MISSOULA COUNTY
INVITATION FOR BID ADDENDUM

IFB NAME: Missoula County 311 Woody St. Remodel
DUE DATE: October 8th, 2026 @ 4:00pm., Local time

ADDENDUM NUMBER: 1 **09-2026-03-A**

Attached are written questions received in response to the IFB. These questions, along with the County's responses, become an official amendment to this IFB.

1 1ST FLOOR DEMO PLAN
1/4" = 1'-0"

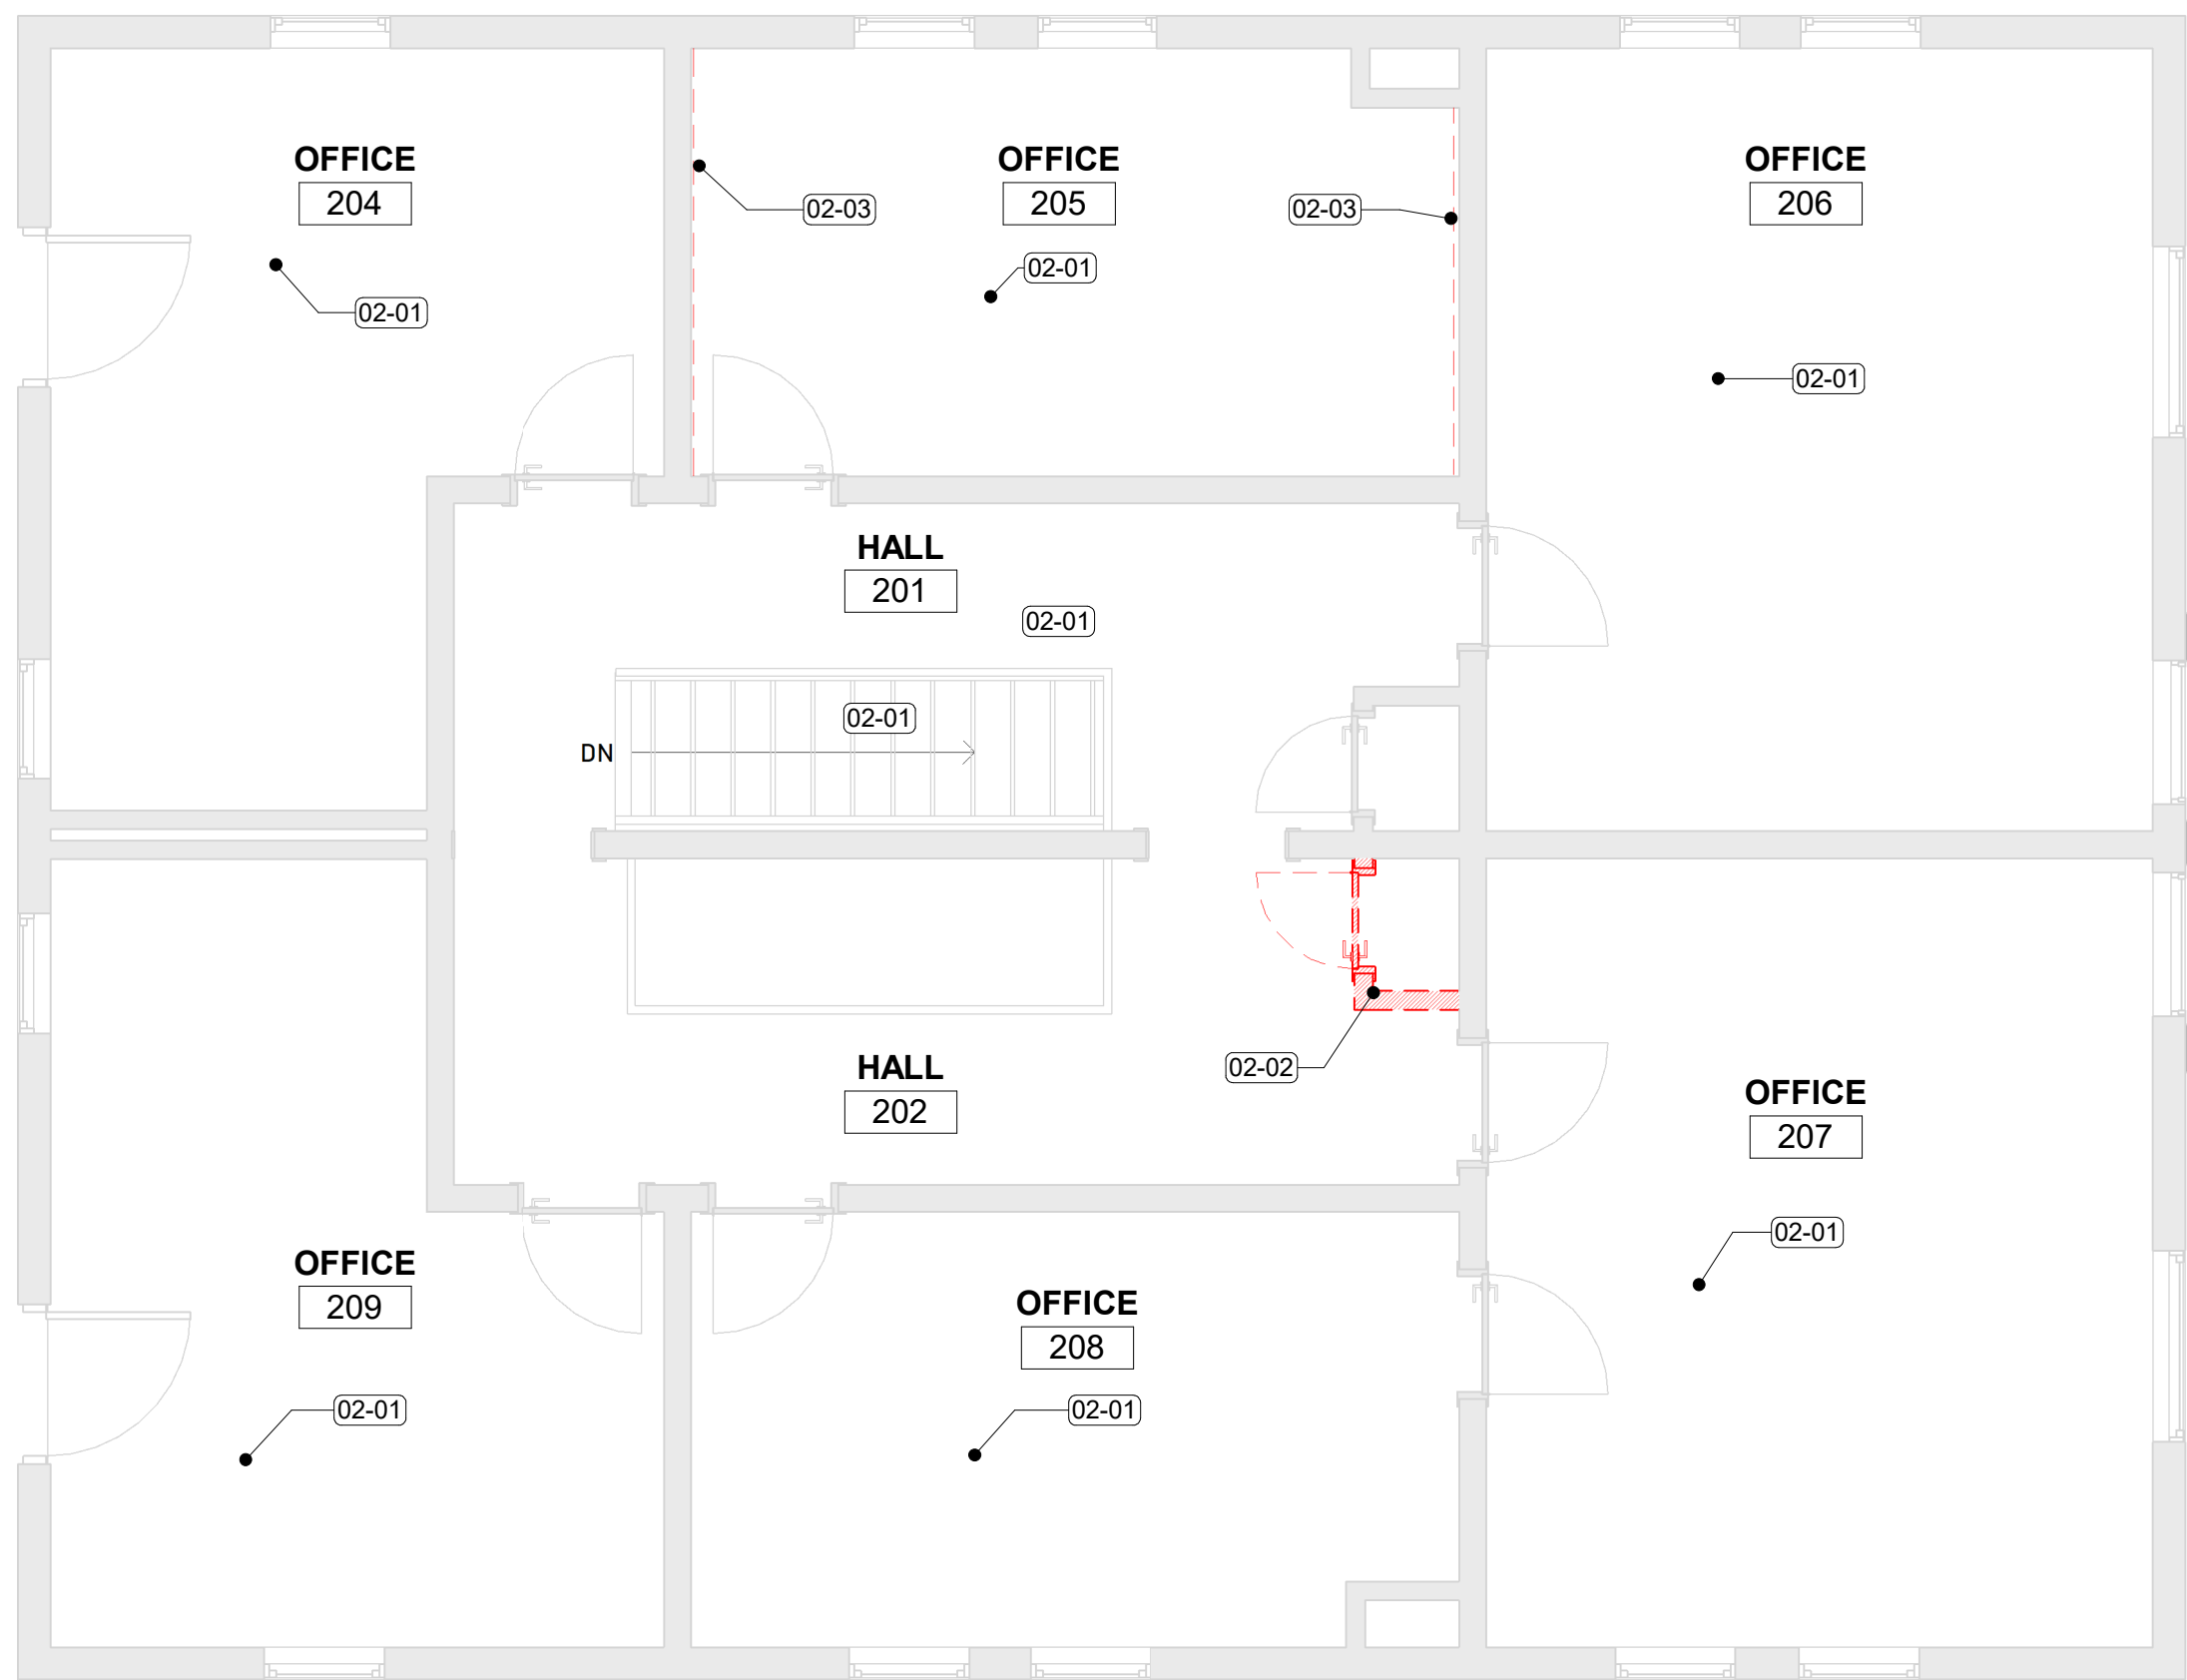
East and South walls in restroom 107 are to have the wall paper and backing board demolished to facilitate sink relocation and grab bar installation. A new ¼" layer of drywall is to be installed, taped, textured and painted. Refer to revised sheets AD2.11, A2.11 and A5.01.

1 1ST FLOOR
A2.11 1/4" = 1'-0"

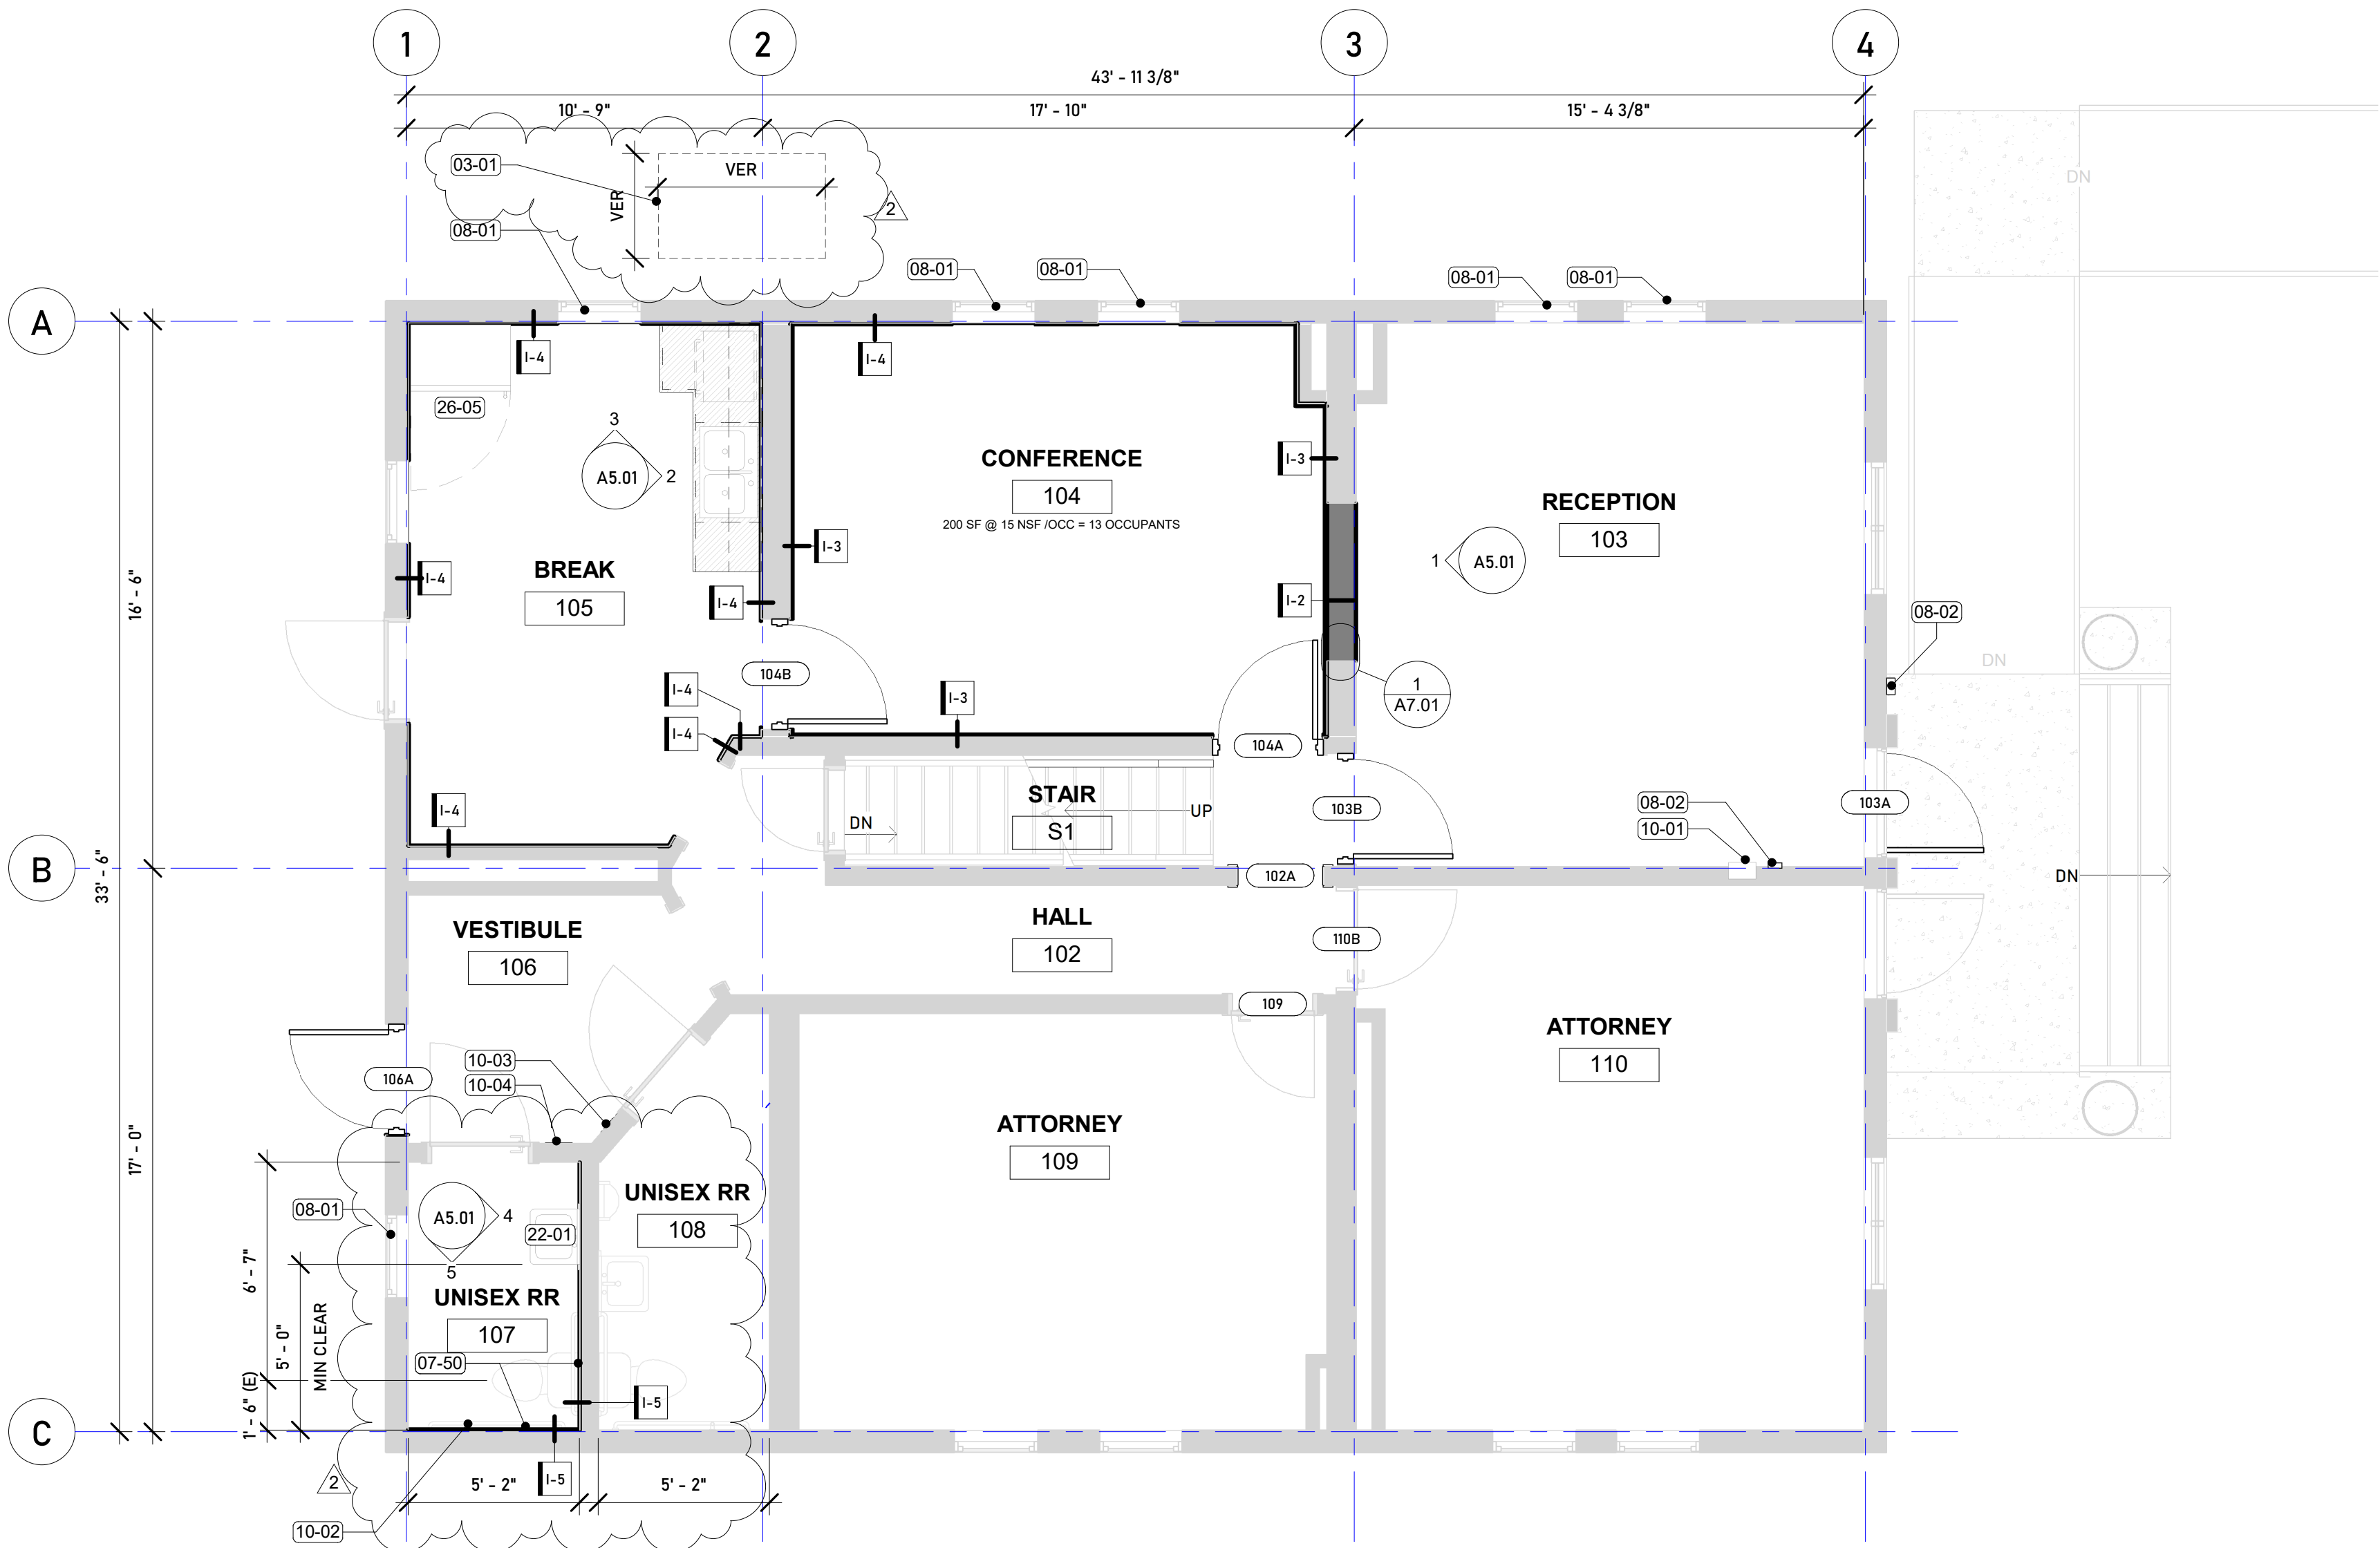
Question #1: I want to confirm there will not be any new sound insulation between offices, conference room, ceiling, or exterior walls. Only in walls called out on A2.11 and A2.12. Please confirm.

New wall types I-1, I-2 and I-3 receive sound batt insulation. The wall cavity in conference room will be exposed during lead abatement by county. Refer to revised sheet A2.11.

1 ROOF PLAN
1/4" = 1'-0"

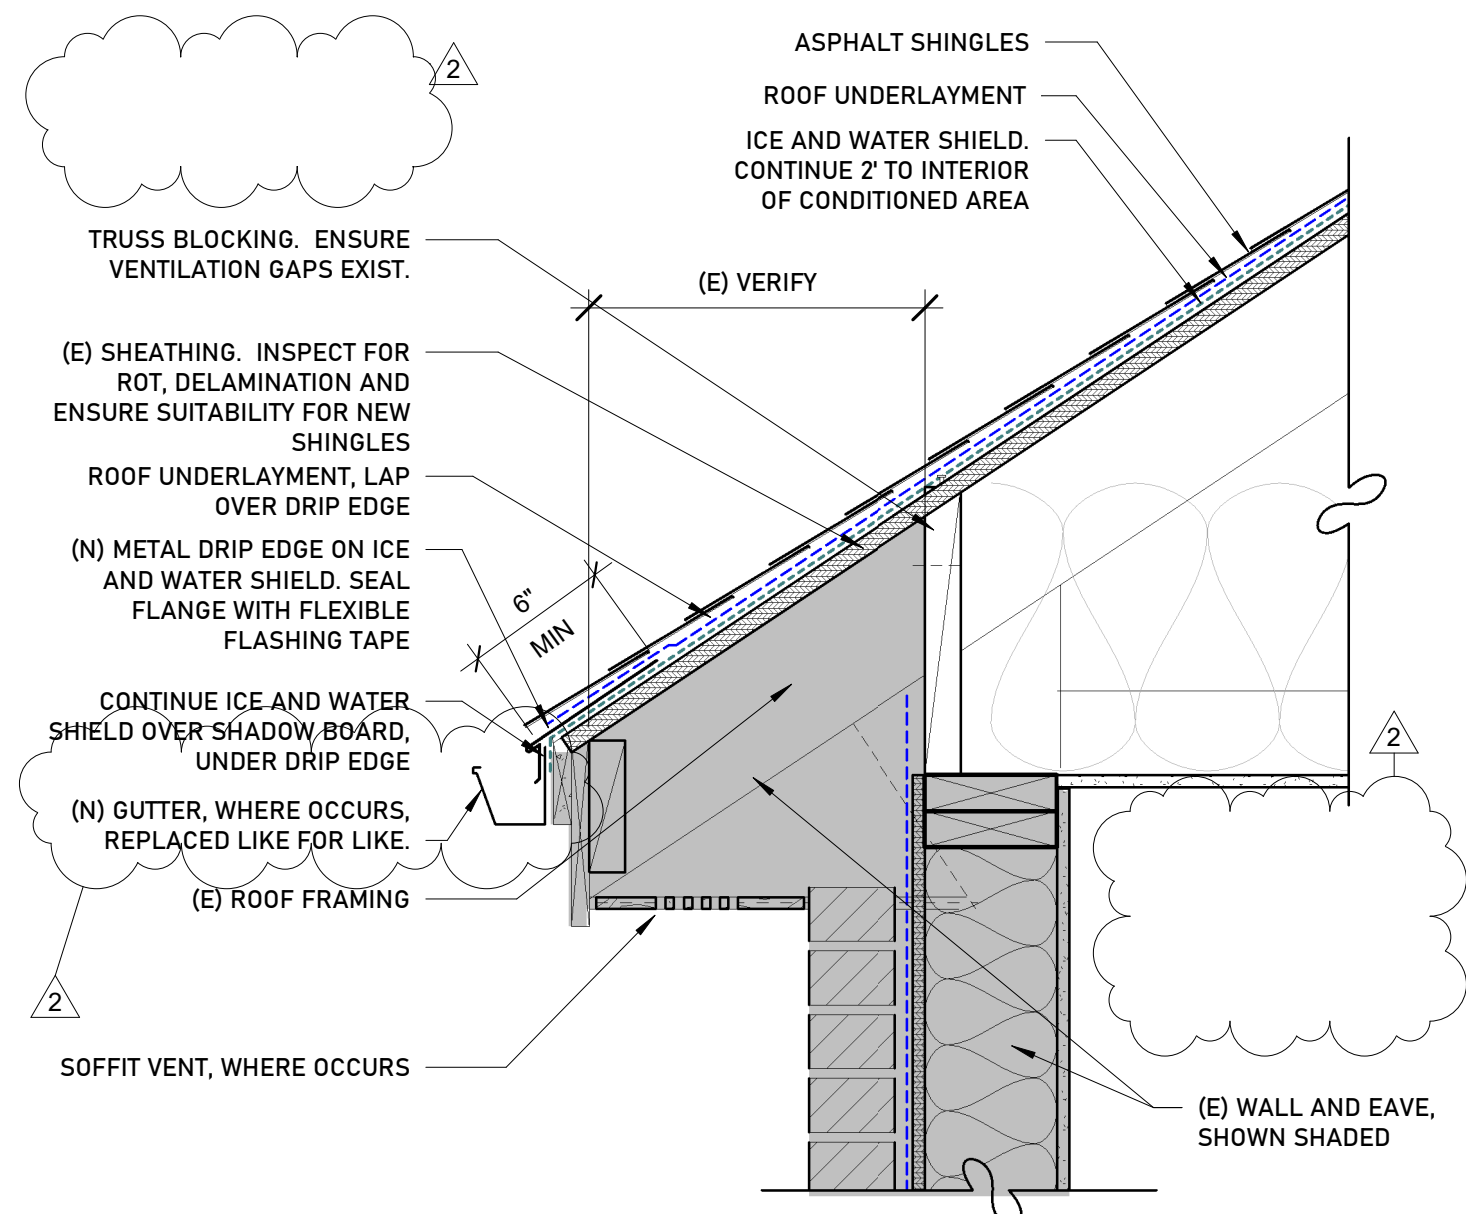
4. **Attic insulation:** Roof Details and assemblies have been revised to retain existing batt insulation. Insulation may require temporary relocation to facilitate electrical work. Refer to sheet A2.13
